### Response to Submissions

Eliwana Iron Ore Mine, EPA Assessment 2125.

EW-RP-EN-0003.001\_2

**Figure 3:** Updated Figure 25 (Map A to E)

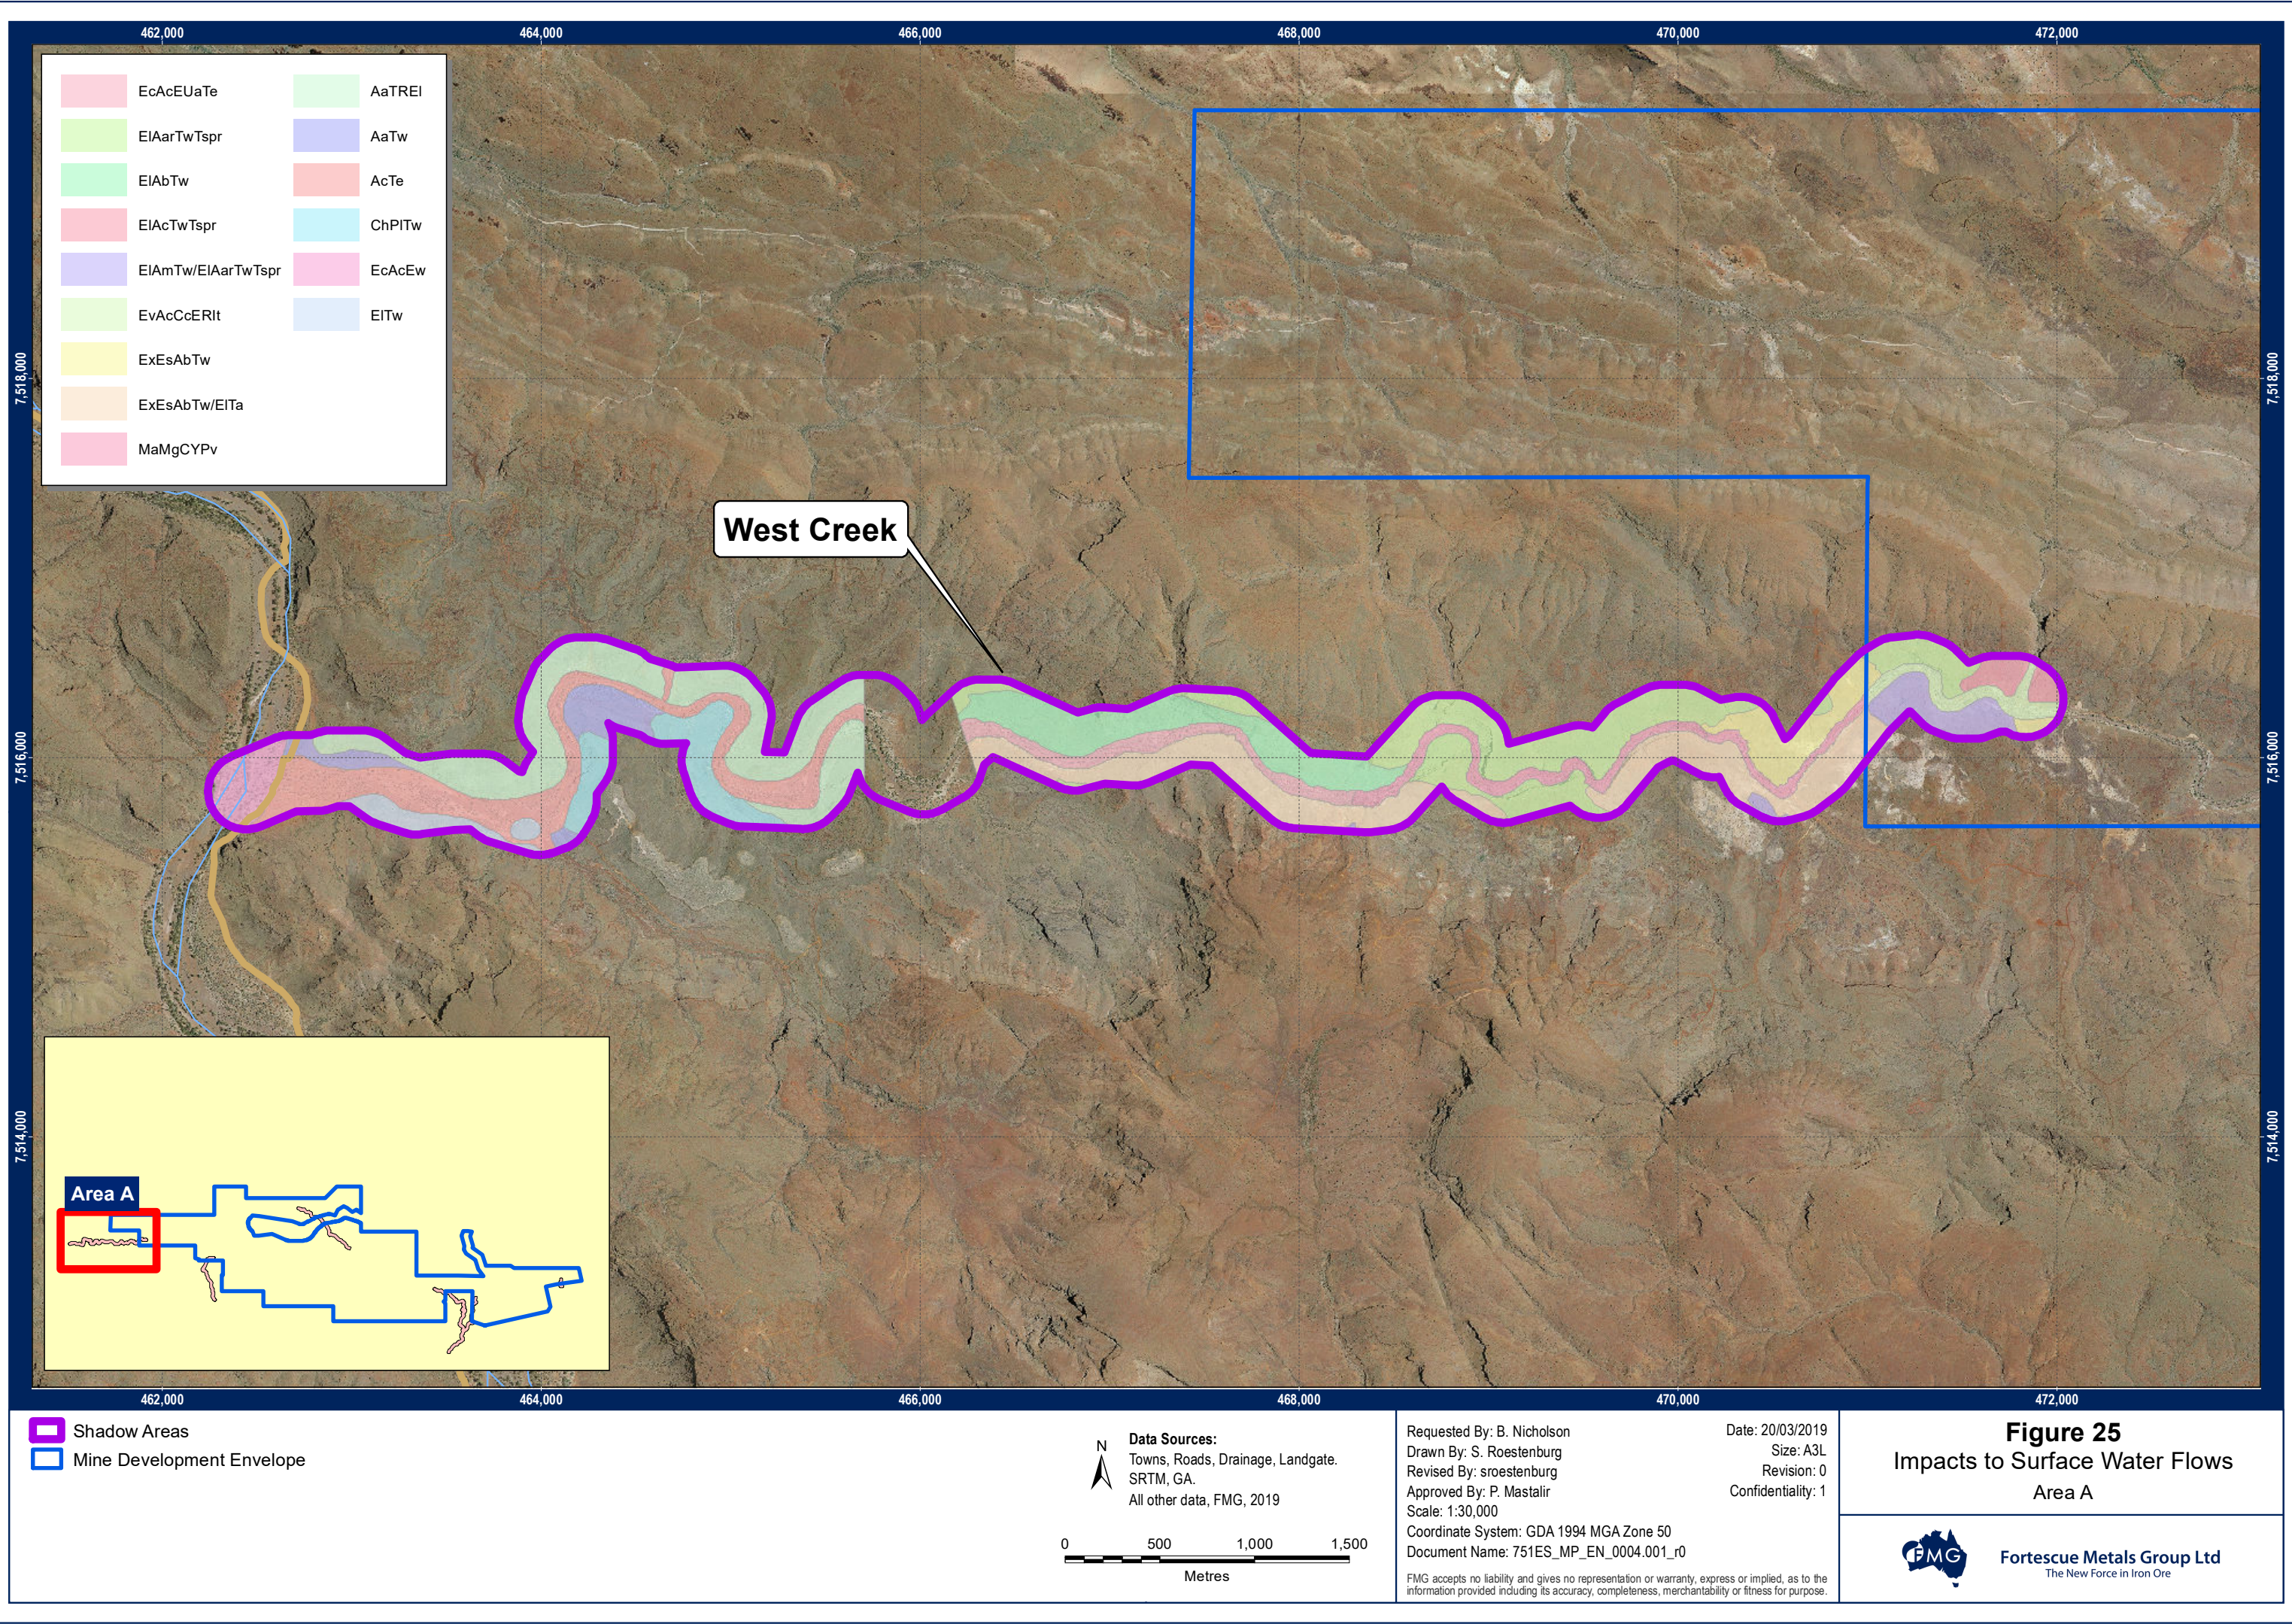
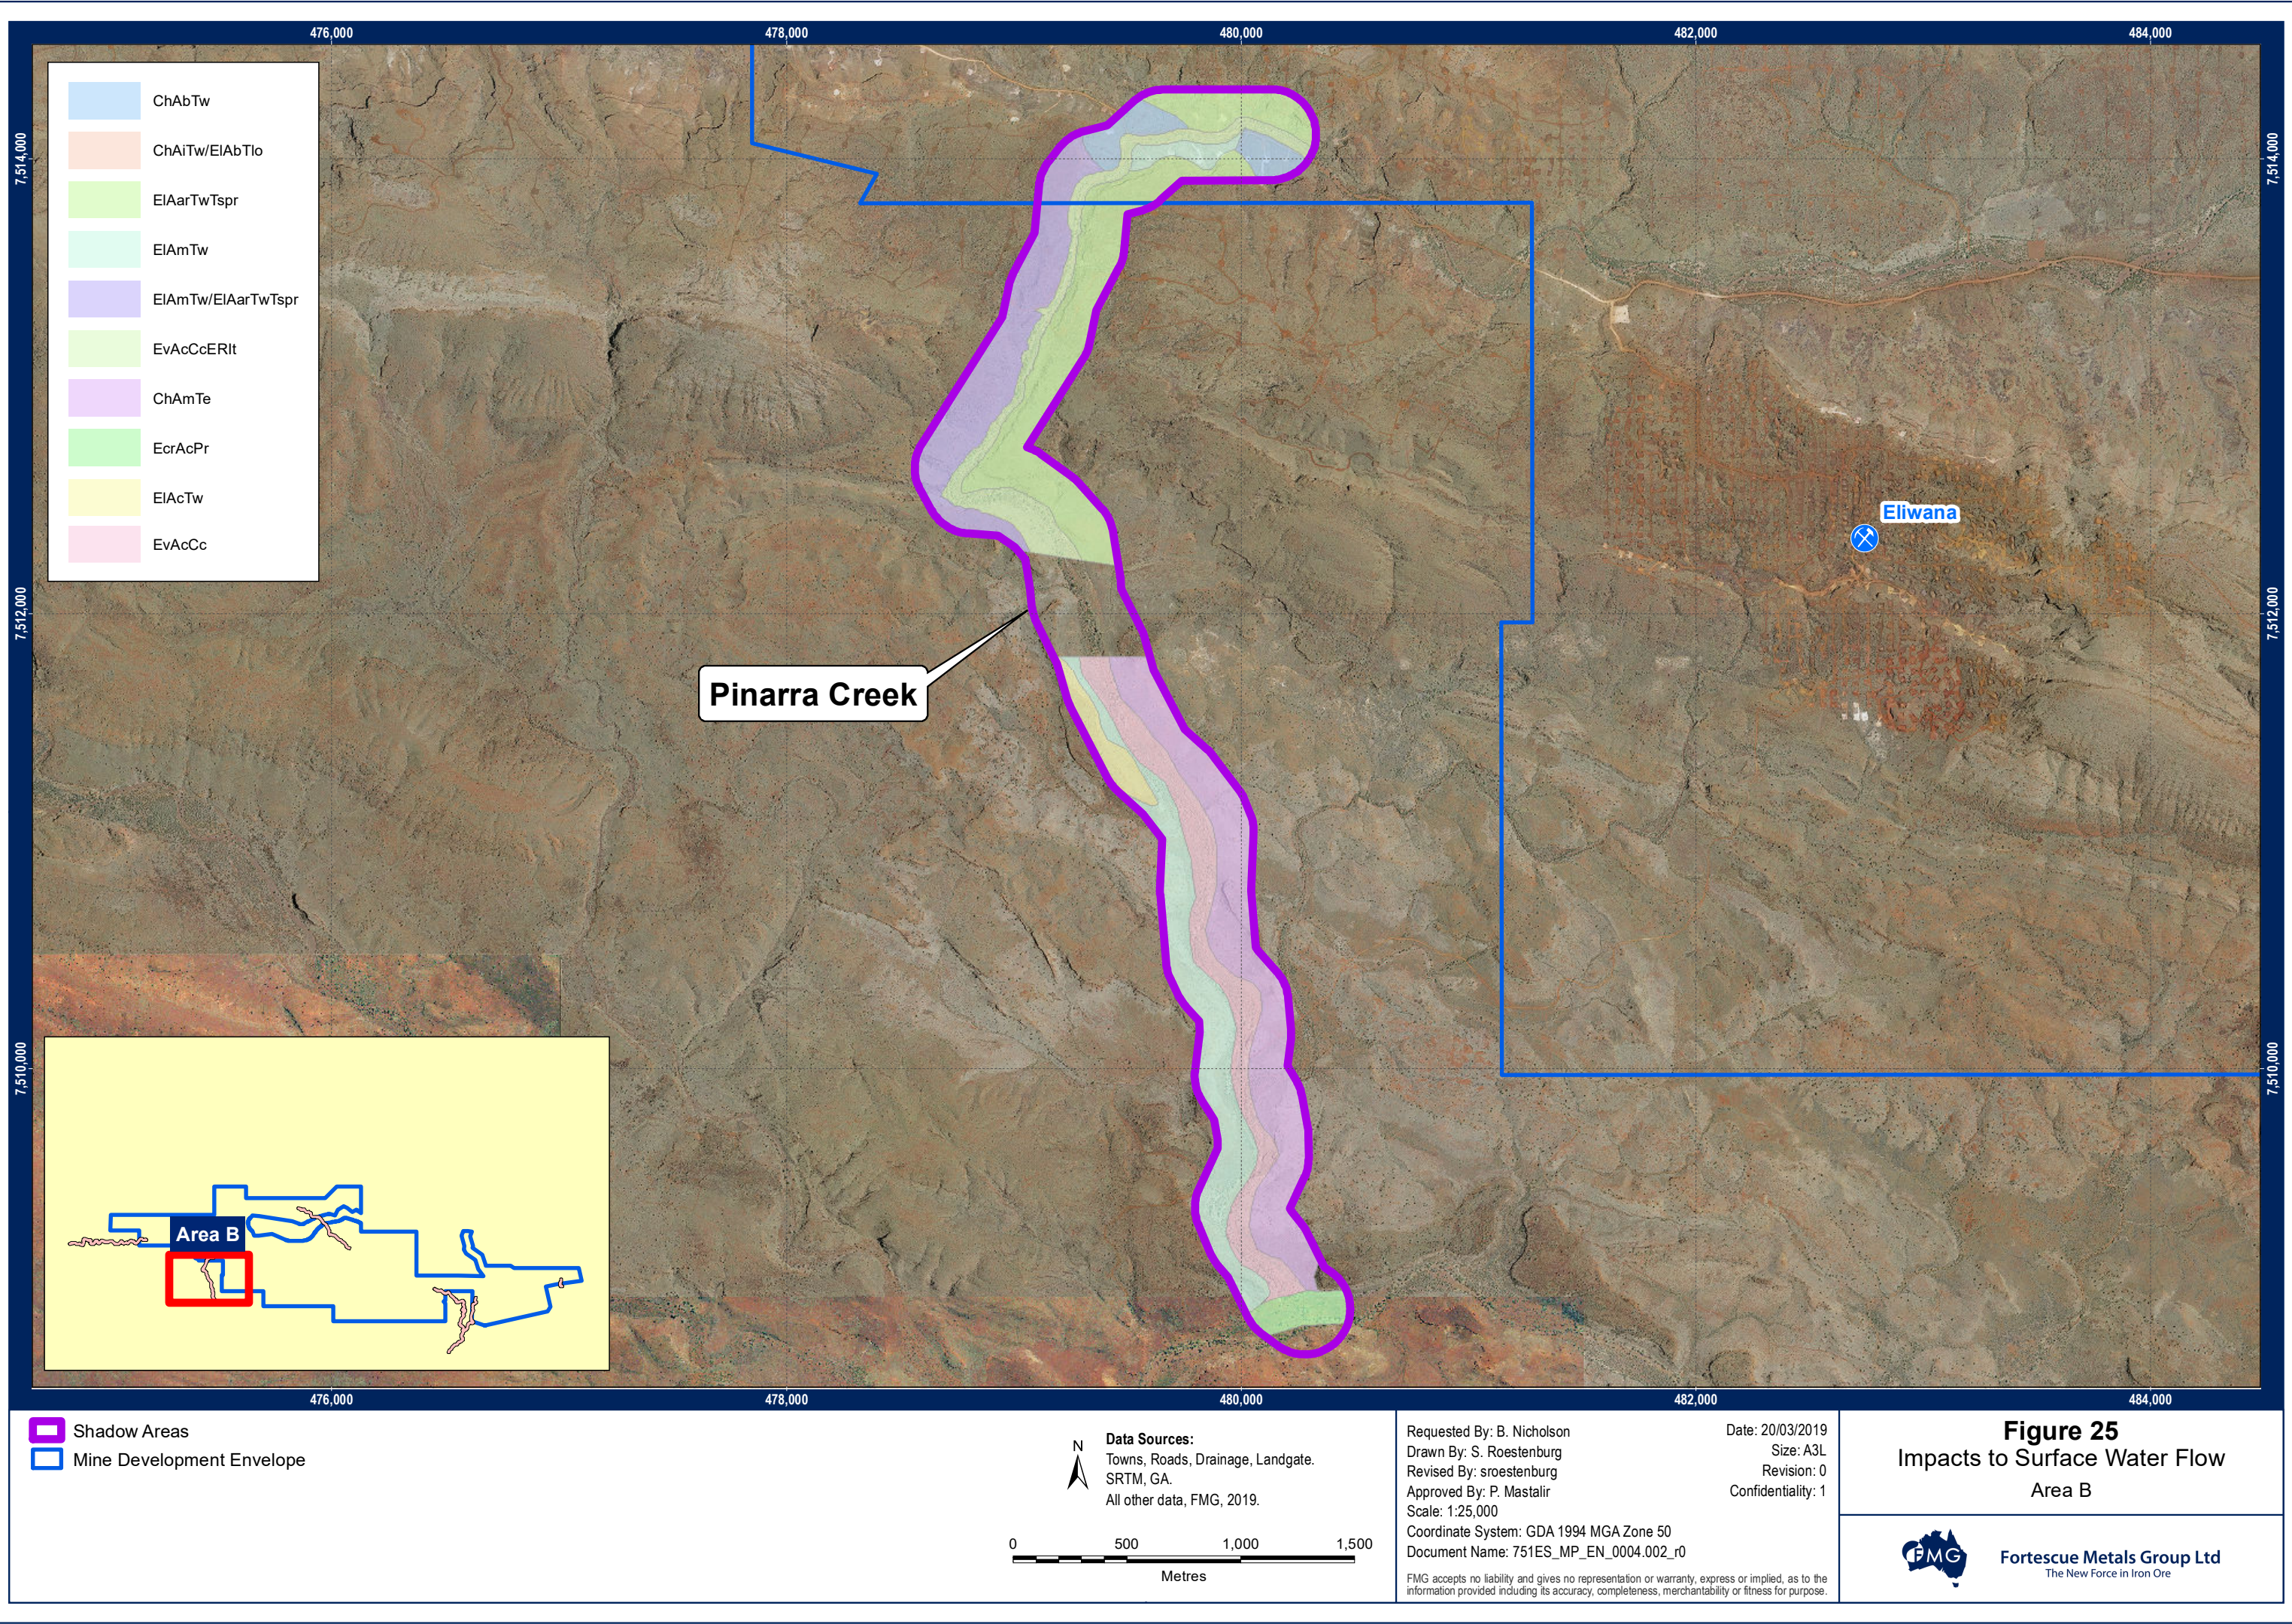
9	DWER (RSD)	Assessment of water regime change impacts on riparian vegetation has been separated into surface water and groundwater – resulting in some areas being assessed twice (particularly West Creek – Figure 19 and 25, Area A).  Given that reduced flows would lead to reduced local recharge and hence groundwater levels (as shown in the conceptual models), changes in both water regimes should not be considered as separate impacts. Presenting these assessments separately also makes it onerous to develop a clear picture of the area of vegetation at risk from indirect impacts – although a cumulative impacts table is presented elsewhere in the document.	The separate consideration of impacts to riparian vegetation from changes to surface water and changes to groundwater drawdown is deliberate and necessary to meet the requirements of the ESD. Clearly, there are areas within the MDE that are subject to groundwater drawdown and there are other areas that are subject to changes in surface water flow. In some areas, particularly vegetation dominated by <i>Eucalyptus victrix</i> , there may be vegetation that is dependent on both surface and groundwater for its water requirements, depending on the baseline depth to groundwater. In these areas, impacts to riparian vegetation may be caused by either groundwater drawdown, or reduced surface water flow, or both. For instance, the ERD recognises that in some areas within the MDE, particularly in close proximity to the West End and Talisman mining areas, <i>E. victrix</i> dominated vegetation occurs in areas of drawdown but is far more likely to be impacted by the changes to surface water flow (Table 30 of the ERD).  Fortescue consider that it is very clear which areas of groundwater dependent vegetation are at risk from groundwater drawdown. Fortescue also consider that areas of riparian vegetation downstream from the mining area are very clearly articulated in Section 4.6.5.9.
